STATE OF NORTH CAROLINA
DEPARTMENT OF TRANSPORTATION

May 1, 2020

Subject: Revised Modification Request for the Section 404 Individual Permit and Section 401 Water Quality Certification for the proposed Havelock Bypass in Craven County. TIP No. R-1015. Debit \$ 570 from WBS 34360.1.2

PERMIT DRAWING SHEET 93 OF 167

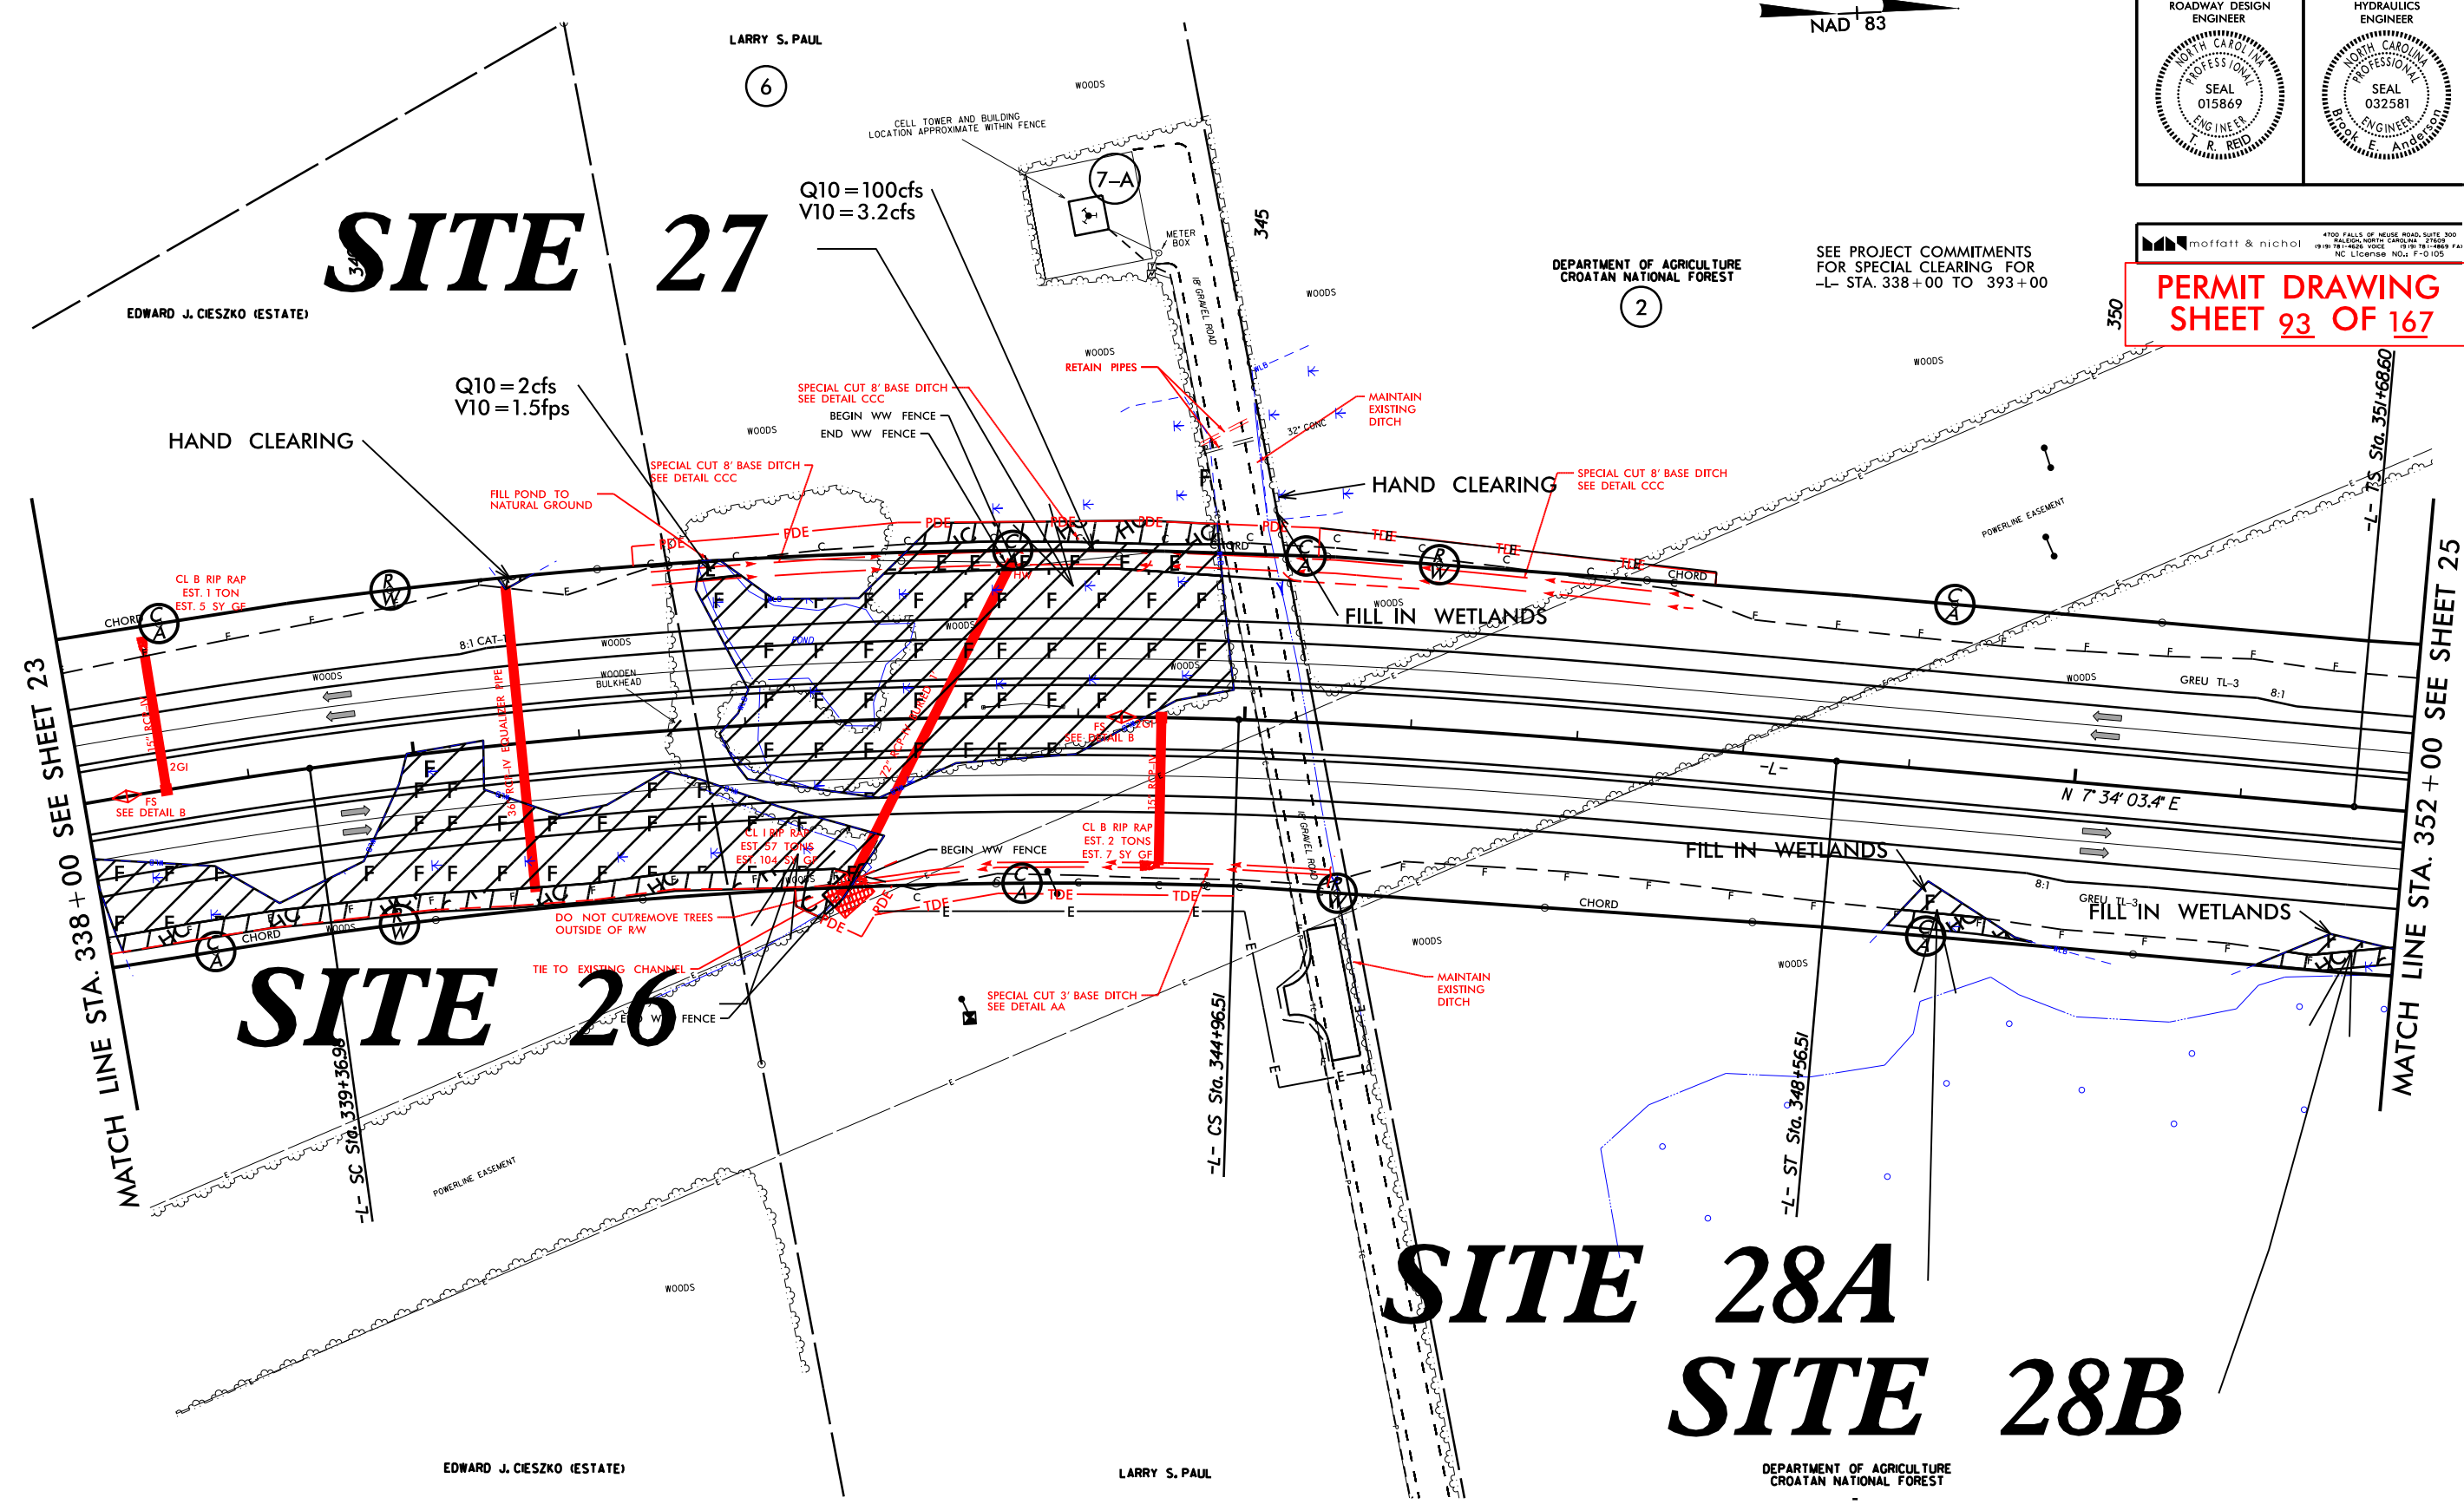
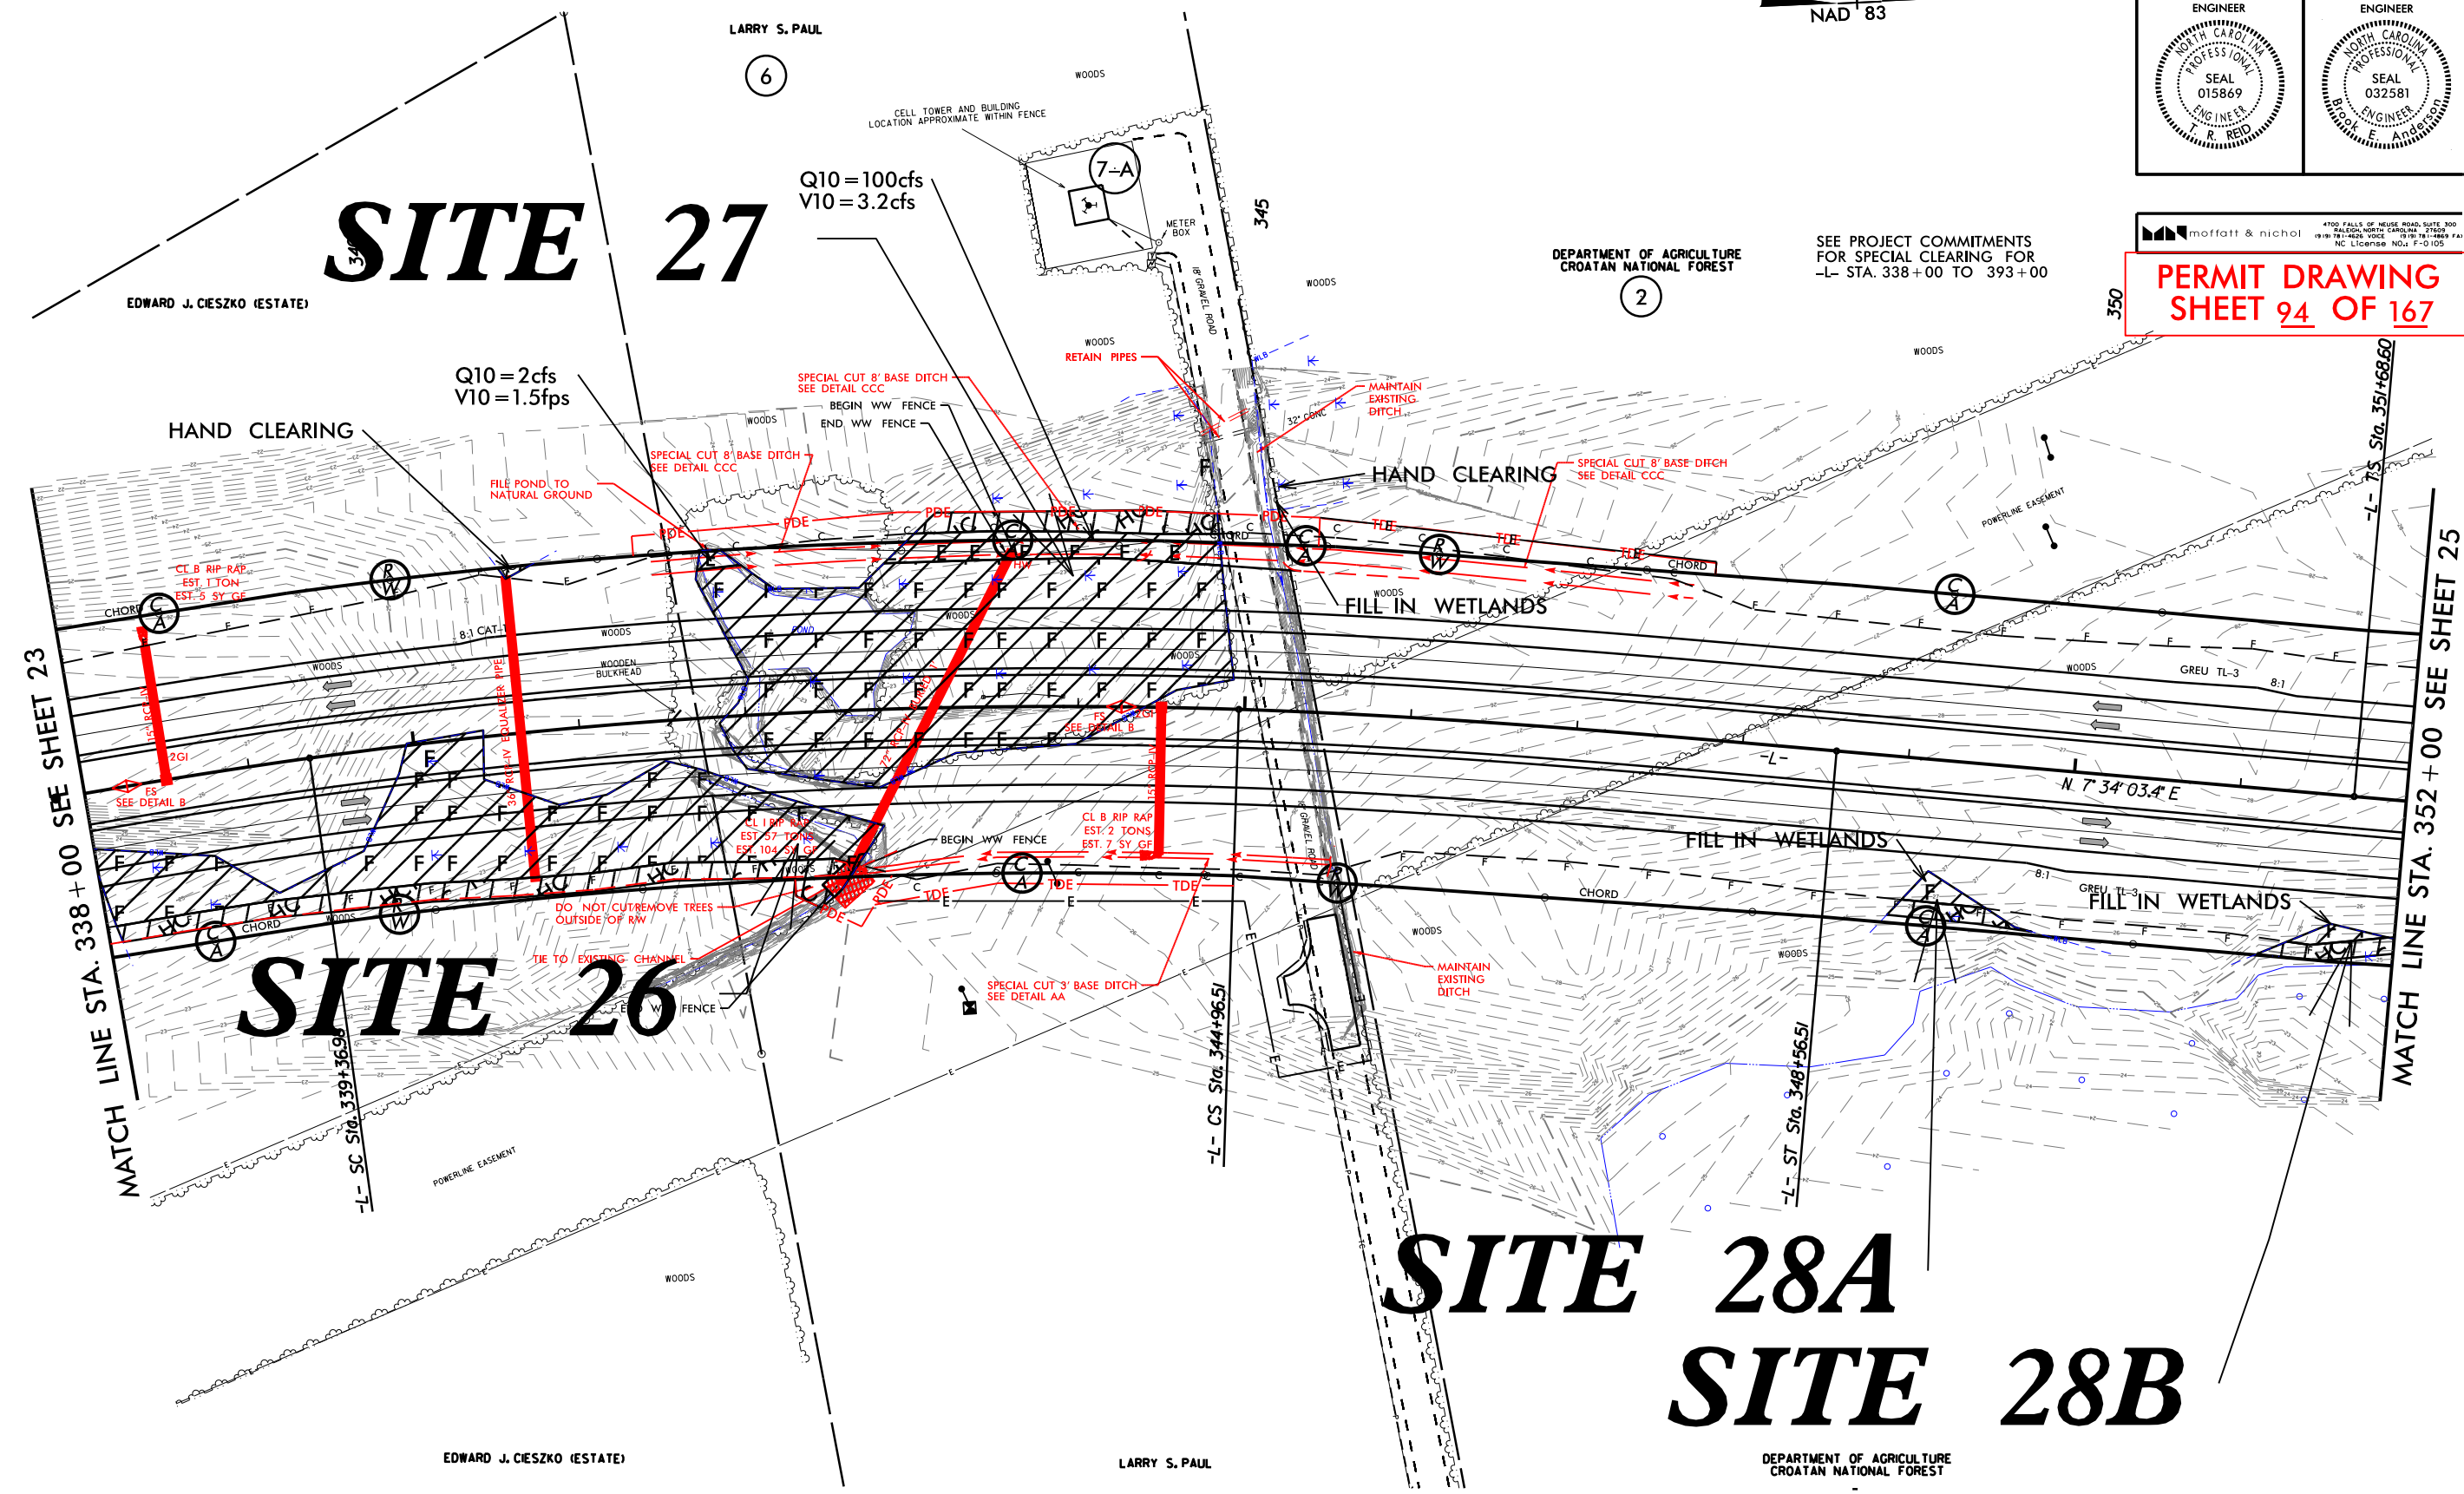
- Site 26: omitted in 3/12/20 modification request, (permit sheets 93 & 94). Slope stake lines were updated due to error in cross slope reported on plan sheets versus cross-sections. Fill in wetlands reduced by 0.01 acre. Hand Clearing increased, but the reported amount did not change.

- Fill decreased by 0.0098 acre, Hand Clearing increased by 0.0076 acre (new = 0.1139 acre, old 0.1063 acre)
- Site 27: omitted in 3/12/20 modification request (permit sheets 93 & 94). Access drive was removed. Fill in wetlands reduced by 0.04 acre. Excavation in Wetlands increased by 0.03 acre. Hand Clearing reduced by 0.01 ac.
